Determination 2008/113

Safety barriers to a swimming pool at 2 Rawene Avenue, Westmere, Auckland

Figure 1: The pool area as detailed in the application for the amendment to the building consent

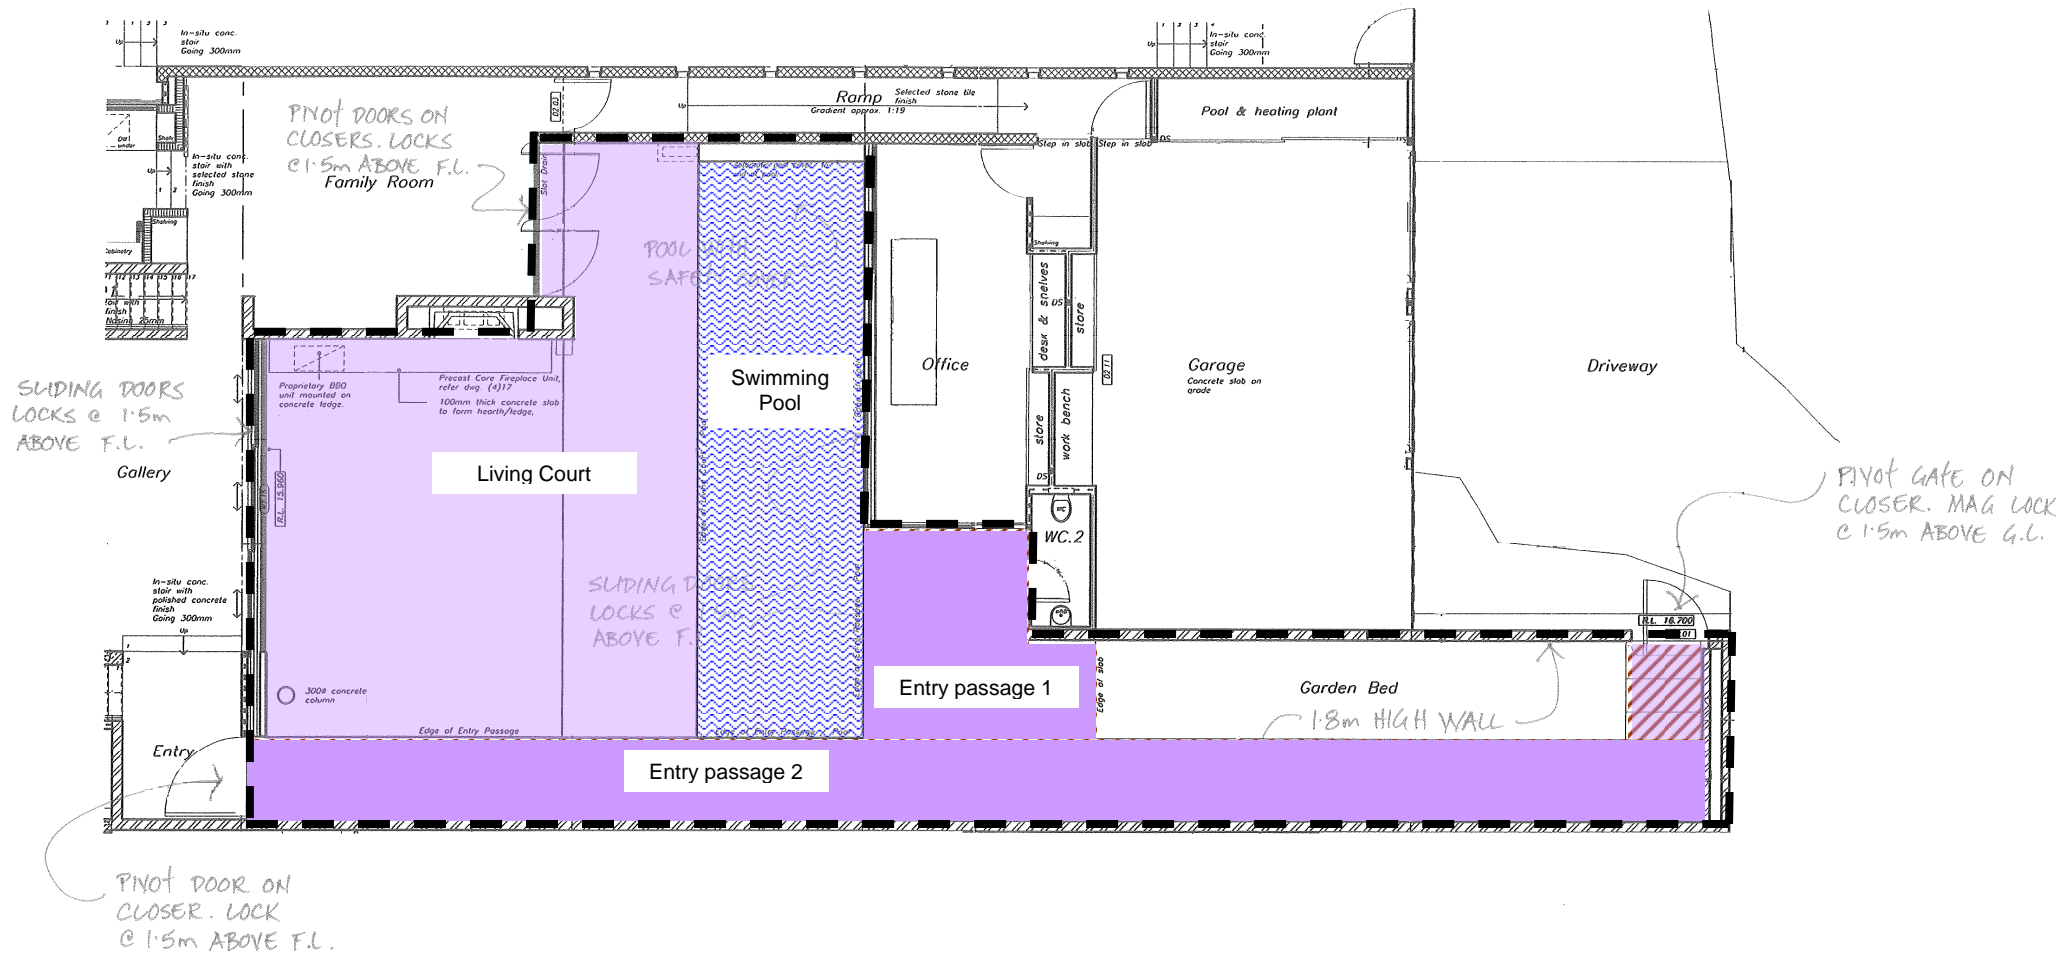
- 3.3 The external access to the pool area is via a 1600mm high pivoted gate at the road, which is self-closing and automatically latched with an electro-magnetic lock fixed 1500mm above floor level. Access is controlled by a security keypad/intercom.

- 3.4 Internal access is via the following doors, none of which are self-closing or self-latching. The doors have locks that are fixed 1500mm above floor level:

- One pivoting door on a closer lock.
 - One single non-self-closing or latching sliding door with a lock.
 - Two sets of three non-self-closing or latching sliding doors with locks.

4.4 The authority was of the opinion that the installation of a pool fence separating the main entry from the pool area was “both possible and reasonable”. In addition, it was considered that the elongated entry did not meet the requirements of Clause 2.2 of NZS 8500. The authority stated that additional matters relating to NZS 8500 were:

- The doors required a lockable door latch rather than just a lock.
- How the door latches on the pivoting doors and gate will function?
- Alarms on the house doors had to comply with U12017.
- Details of the motion sensor were lacking.

6.4 However, as described in paragraph 3, the main access way to the property passes through or adjoins the pool area. This situation does not qualify as an “immediate pool areas” as defined in the *Hickman* decision. In addition, as set out in section 2.9 of NZS 8500, “access to the house from outside the property shall not be through the pool area”. As previously described, the house access is through the pool area, so in this respect, the pool area does not meet the requirements of the standard, in this case.

- 9.1 For the reasons set out above I conclude that the proposed amendment to the building consent does not comply with the Building Code. I must therefore confirm the territorial authority’s decision to refuse to issue the amendment.

- (a) determine that the swimming pool and its associated safety barriers, as specified in the proposed amendment, do not comply with clause F4, and
- (b) confirm the territorial authority's decision to not to issue an amendment to the building consent.
